HOUSING AND DEVELOPMENT TASK FORCE

Meeting Agenda

THE CITY AND BOROUGH OF JUNEAU, ALASKA
HOUSING & DEVELOPMENT TASK FORCE
December 10, 2021 – *DRAFT* Meeting Minutes

TABLE 49.25.400

O-LOT

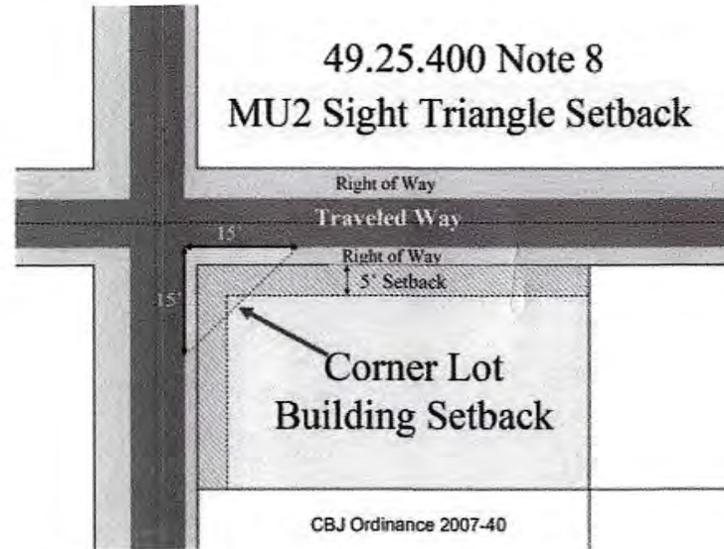
O-LOT SHOULD NOT REQUIRE A COMMON WALL.

DRIVEWAY LOCATION IS NOT DEFINED

SIZE IS TOO RESTRICTIVE - 2-CAR GARAGES SHOULD BE ALLOWED

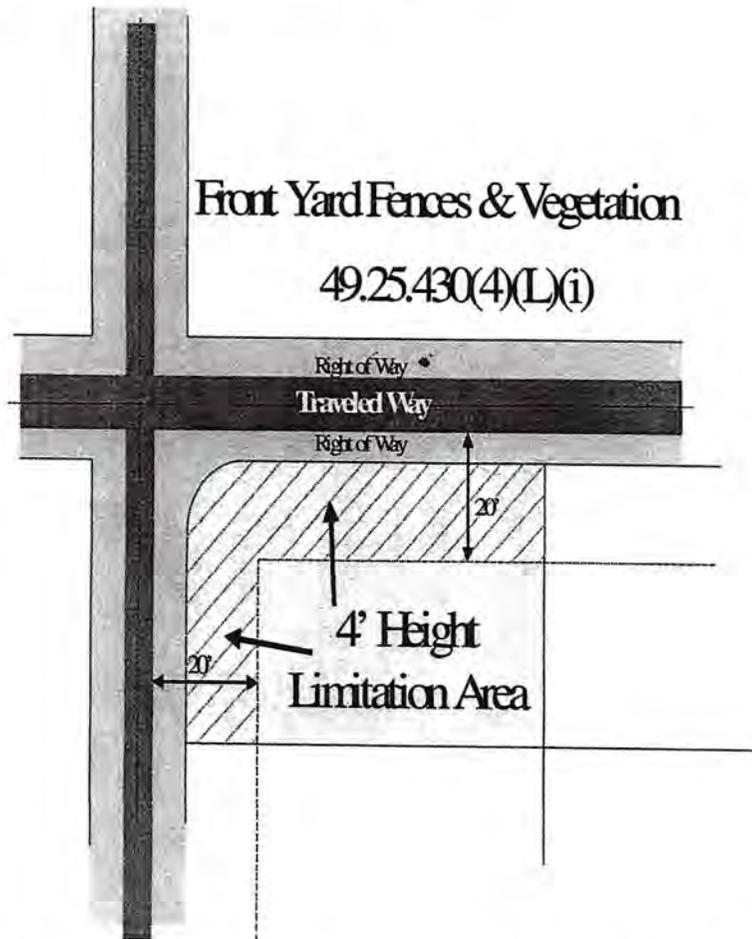
Is this problematic? Seems to be considering the number of words contained within
